NOTICE OF COMPLAINT

Re: Docket No. 20180087-EI - Complaint against Florida Power & Light Company regarding safety of transformers supplying power to six residential buildings in South Winds Condominium, by Manuel Blanco.

MANUEL BLANCO'S COMPLAINT
DATED APRIL 3, 2018
TO
THE FLORIDA PUBLIC SERVICE COMMISSION
RE
FLORIDA POWER & LIGHT COMPANY
PURSUANT TO
FLORIDA ADMINISTRATIVE CODE
RULE 25-22.036 AND RULE 28-106.104

EXHIBIT I

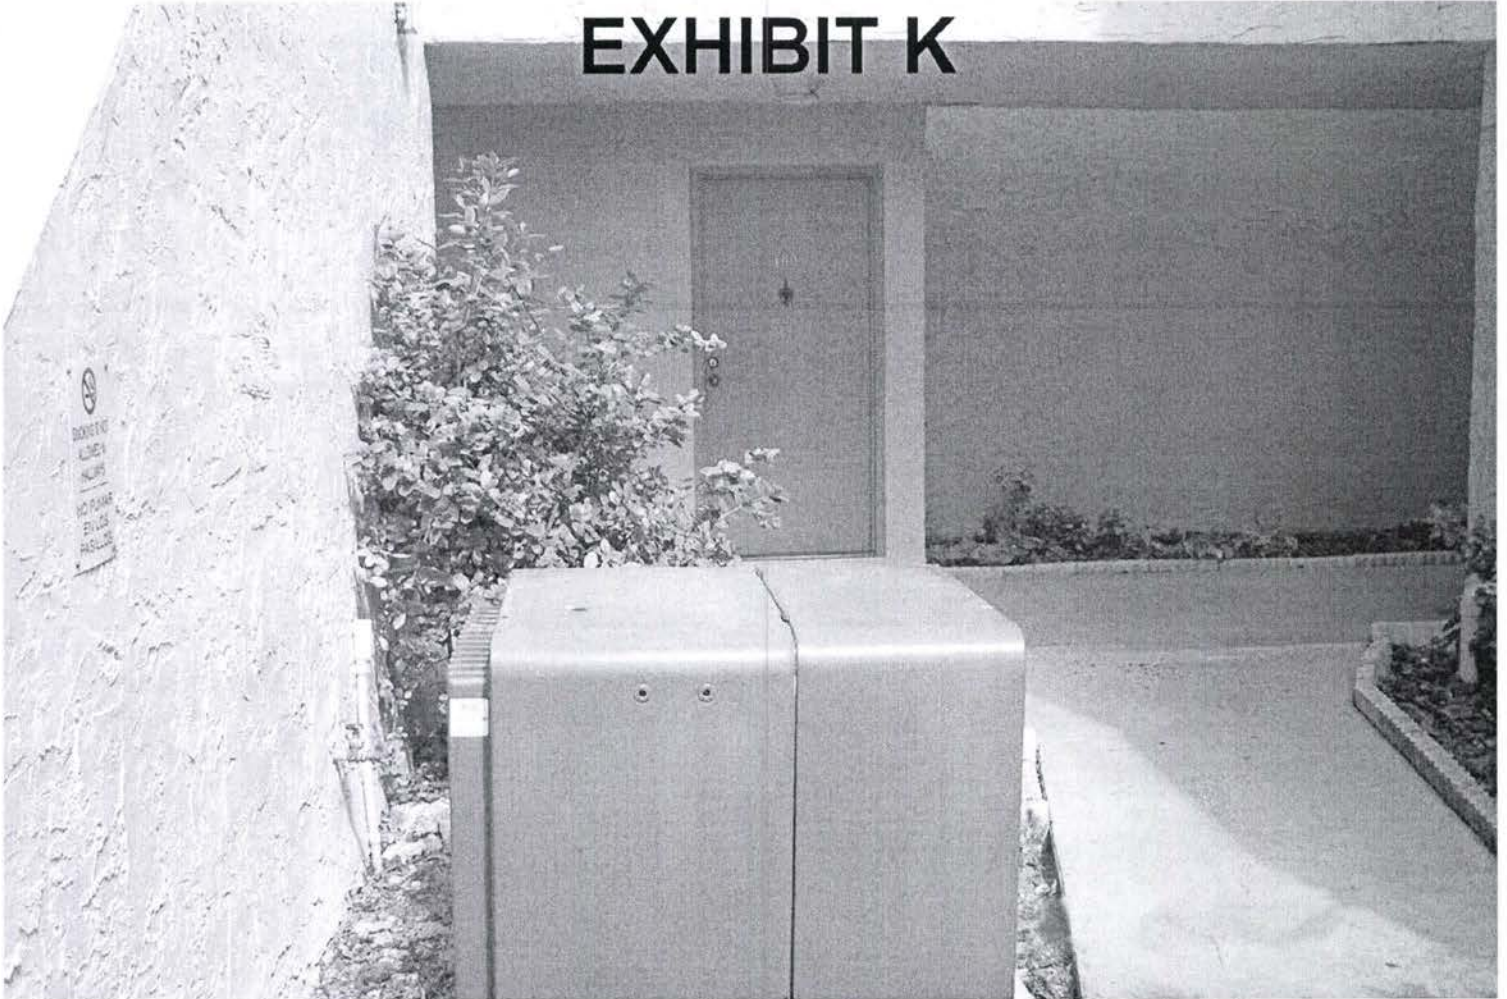
EXHIBIT I is a photo in color taken 4/1/2018 of the liquid-filled transformer installed southeast of Building 9311 between the walkway and the stairway. The distance between the transformer and the main door of the condo unit is 15.21 feet. The distance between the back of the transformer and the stairway is 1.83 feet. This transformer at ground level was not designed to withstand flooding caused by a hurricane and therefore flooding could cause this transformer to explode or electrify the water near the transformer long enough to electrocute any person touching the water. This transformer requires clearance for cooling its liquid. The installation of this transformer does not meet the minimum clearance on its back required by FPLESS and does not utilize at least one of the methods to minimize fire hazards described in 2012NESC for outdoor installations of liquid-filled transformers.

Manuel Blanco respectfully requests this relief: (1) that this commission orders FPL to have every transformer in South Winds Condominium meet the minimum three feet clearance on the back of each transformer as required by its Electrical Service Standards; (2) that this commission orders FPL to have every liquid-filled transformer in South Winds Condominium meet the requirements of the 2012 edition of the National Electrical Safety Code for outdoor installations of liquid-filled transformers; (3) that this commission orders FPL to provide clear and convincing evidence to this commission that its transformers in South Winds Condominium can withstand being immersed in water during a hurricane without exploding or electrifying the water near the transformer long enough to electrocute any person touching the water.
